CITY OF PORTLAND, MAINE

HISTORIC PRESERVATION BOARD

HISTORIC PRESERVATION BOARD MEETING

- i. Preliminary Review of Revised Design Proposal for New Construction, 76 Congress Street (site of former St. Lawrence Church sanctuary); Friends of the St. Lawrence Church, Applicant.
- ii. Preliminary Review of Proposed Alterations, 9 Bowdoin Street; Barbara and Robert Burgess, Applicants.

St. Lawrence Arts - North East Rendering

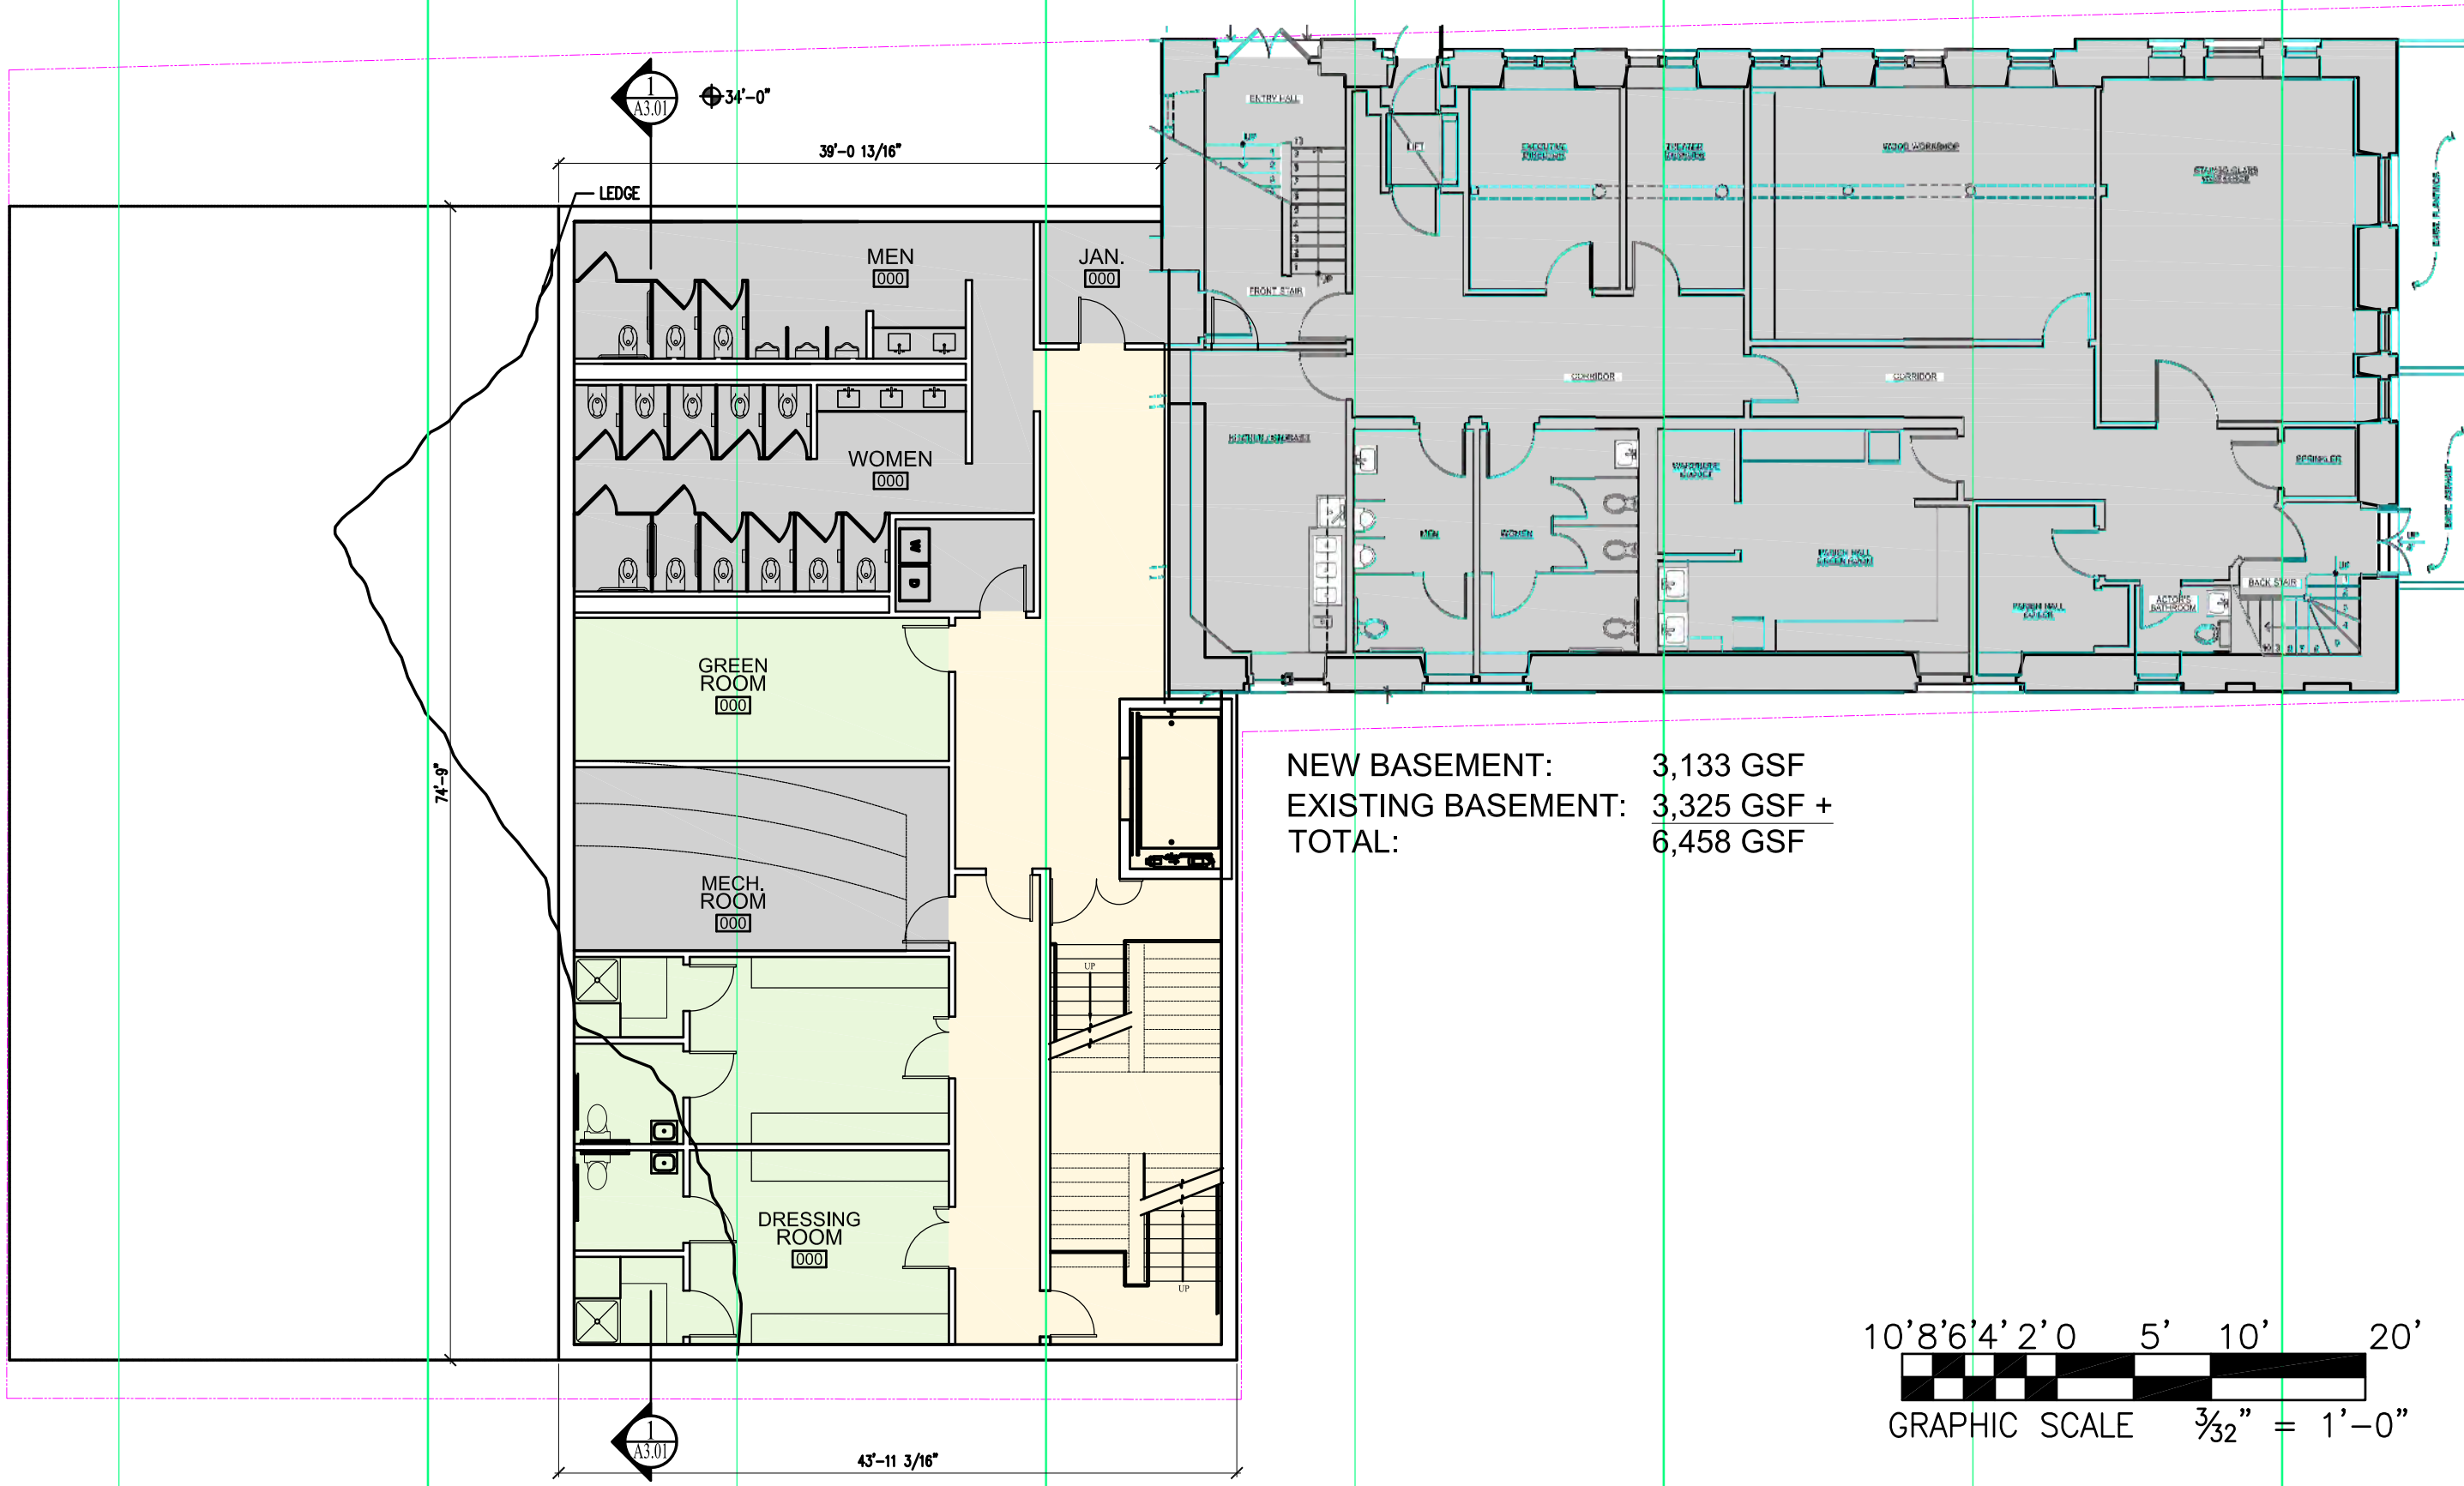
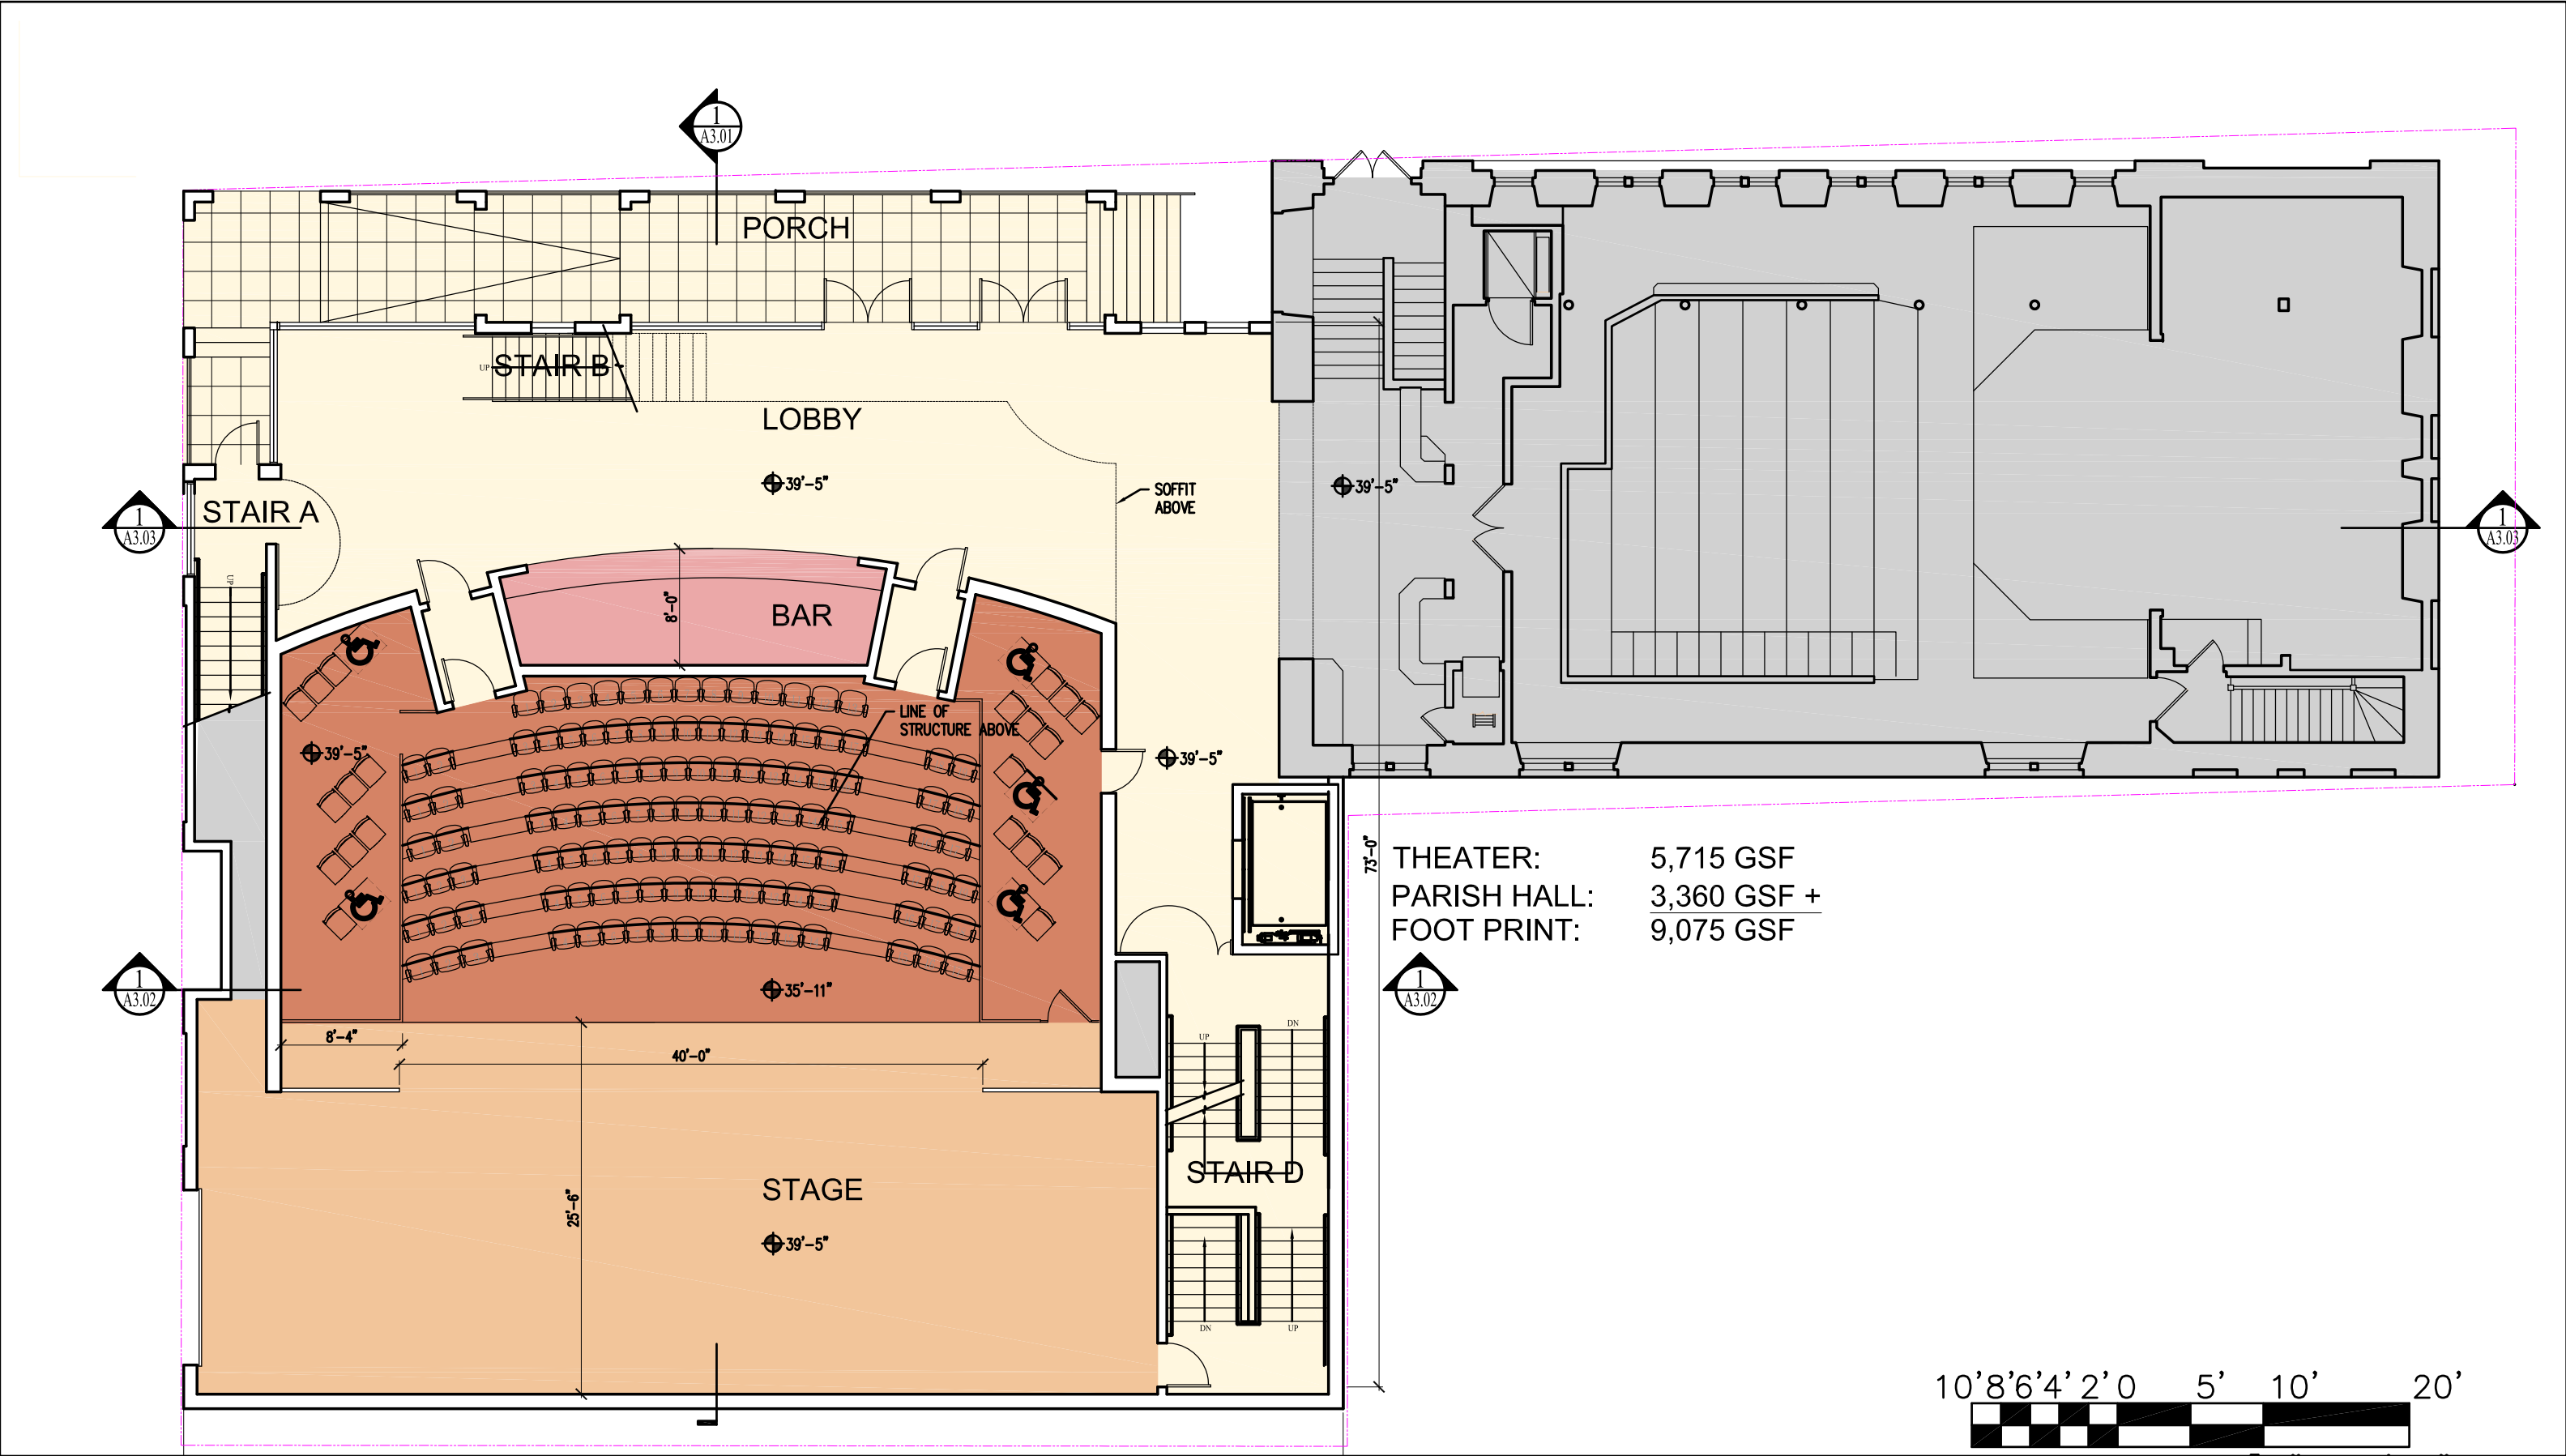
Architect David Lloyd, representing Friends of the St. Lawrence Church, has requested a workshop to present a design proposal for a new addition to the parish hall of the former St. Lawrence Congregational Church at 76 Congress Street. The addition will replace the former church sanctuary which was demolished in 2008.

Note that the enclosed design proposal replaces a previous proposal for the addition that was presented to the Board in 2010. The goal of this preliminary workshop is to provide initial feedback to the applicant and architect on the general scale, massing and design expression of the proposed structure. The Friends of the St. Lawrence will need to embark on an ambitious fundraising campaign in order to build a new arts facility adjoining St. Lawrence's existing parish hall and want to gauge the Board's relative support for the proposed design direction before they present the plans as part of their fundraising initiative.

As Mr. Lloyd states in his letter, the organization received feedback from potential funders that their plans to replicate the original exterior would be inordinately expensive, boosting the overall project costs enormously. Based on this input, the Friends elected to rethink their original plans and hired a new architect to provide design assistance.

recessed and features a glass curtain wall. An elevated plaza is located in front of the recessed glass wall. The upper floor of the building appears to be a sheer-walled rectilinear box. According to the project architect, a perforated metal skin is being considered for the exterior siding. Lighting is also being explored for behind the skin. The top floor, which is set back slightly from Congress Street and considerably from Munjoy Street, is a 10' tall glass-walled space. As planned, it will function as a community meeting room.
